Agreement No. CE 92/2017 (CE) Site Formation and Infrastructure Works for Public Housing Development near Tan Kwai Tsuen, Yuen Long – Investigation, Design and Construction

Proposed Planning Application to the Approved Tong Yan San Tsuen Outline Zoning Plan No. S/YL-TYST/14

APPENDIX F
LANDSCAPE AND VISUAL IMPACT ASSESSMENT
REPORT

Responses to Comments on Landscape and Visual Impact Assessment Report for S16 Planning Application (Intensification Scheme) (Issue 2)

Figure 3.2.d Photomontage of Visually Sensitive Receiver VP4 Public Users of Tan Kwai Tsuen Road Garden

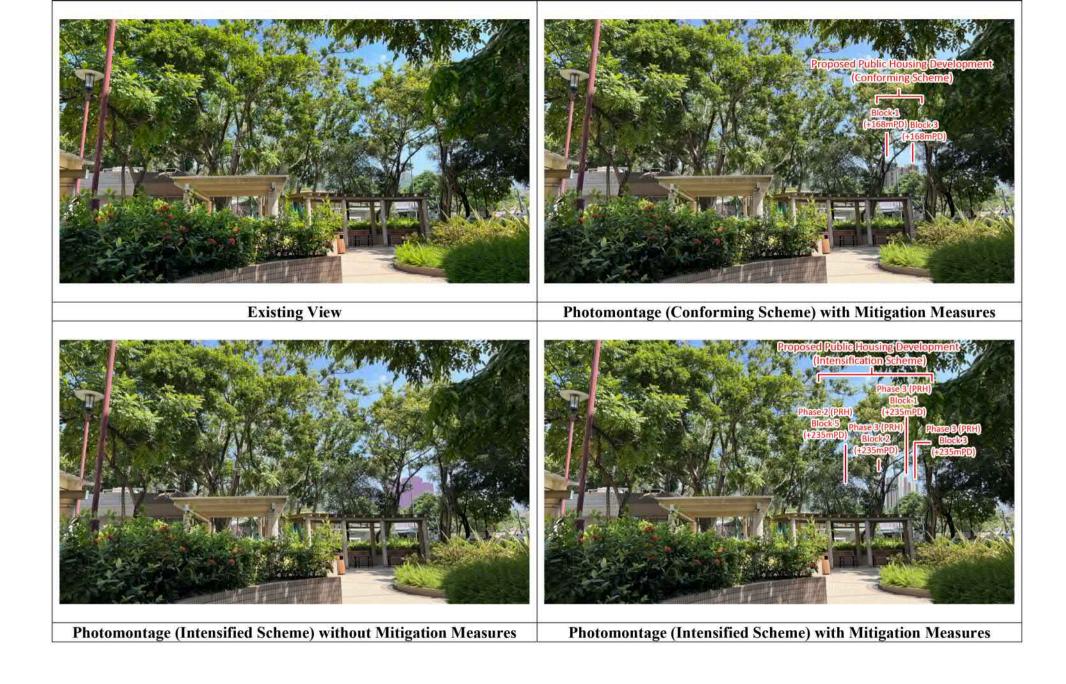
15. Section 3.4 & Figure 3.1 Proposed Viewing Points (VPs) – There is no selected VP from the north of the Site in a shorter distance. Tan Kwai Tsuen Road Garden (VP4) and Hung Tak Road Sitting-out Area (VP5) over 800m away from the Site are selected as VPs instead of Tan Kwai Tsuen Road Sitting-out Area nearer the Site. Please provide justifications in this regard or explore this VP and supplement in the VIA as appropriate.	Noted and the VP at Tan Kwai Tsuen Road Sitting-out Area was not selected as the existing buildings will block the view of the development. A picture of the view is attached for information.

Figure 3.2.h Photomontage of Visually Sensitive Receiver VP8 Public Users near Hung Shui Kiu Light Rail Transit Station

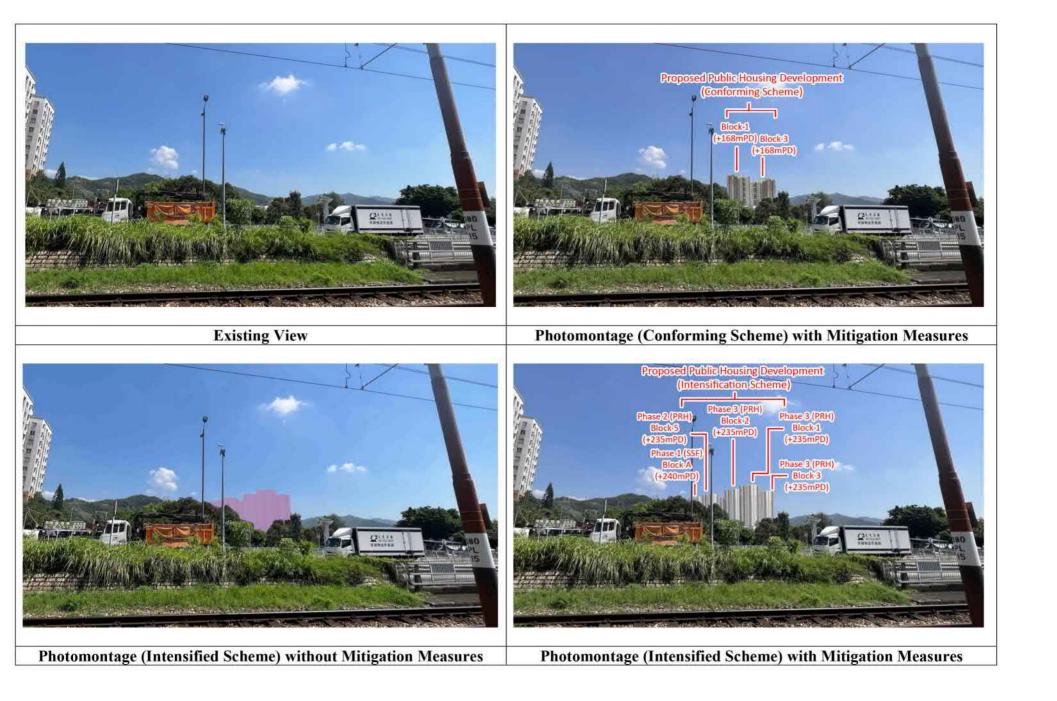
16. Para. 3.7.12 Visual Impact at VPs 8 & 9 – Judging from the photomontages in that the proposed development is the only large-scale high-rise building cluster on the vegetated hillslope, the statement that "The visual composition of the proposed development was still visually compatible with the existing and planned urban context of the area" seems not tenable. Please review.	Noted and paragraph 3.7.12 is updated.

Figure 3.2.i Photomontage of Visually Sensitive Receiver VP9 Public Users near Chung Uk Tsuen Light Rail Transit Station

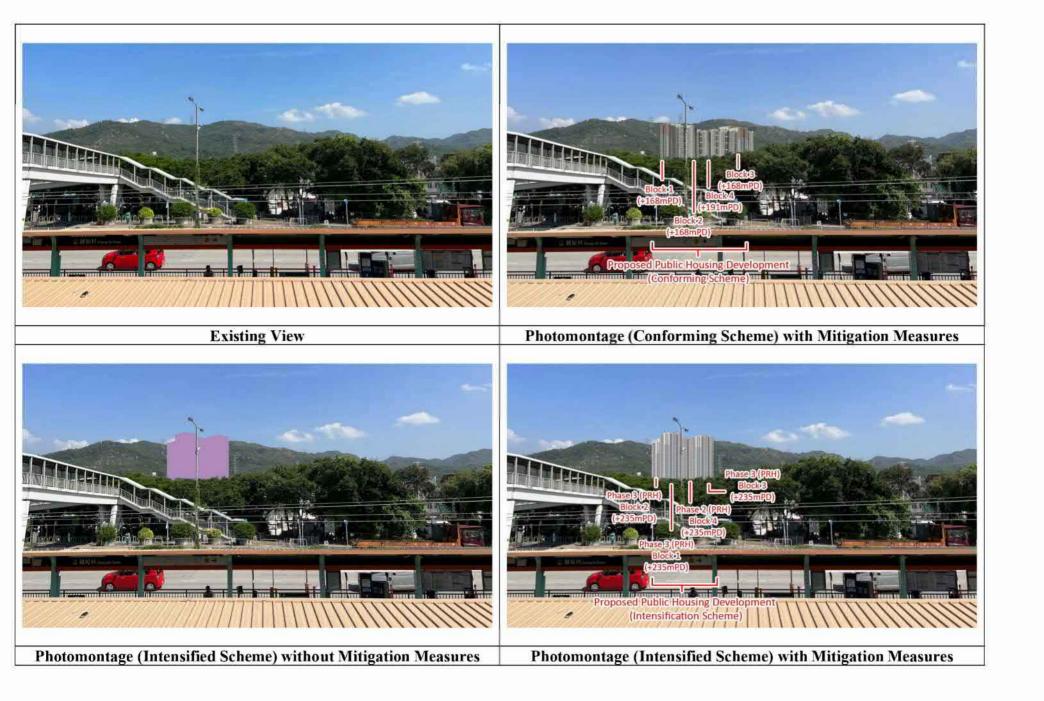
20. Photomontages (General) - The Consultant	Noted and Figure 3.1i to 3.2k are
should ensure the accuracy of all the	revised.
photomontages (i.e. simulation of both the	
conforming and intensification schemes). In	
particular, inaccuracies are found in relevant	
photomontages at VPs 9 to 11 (Figures 3.1i to	
3.2k refer).
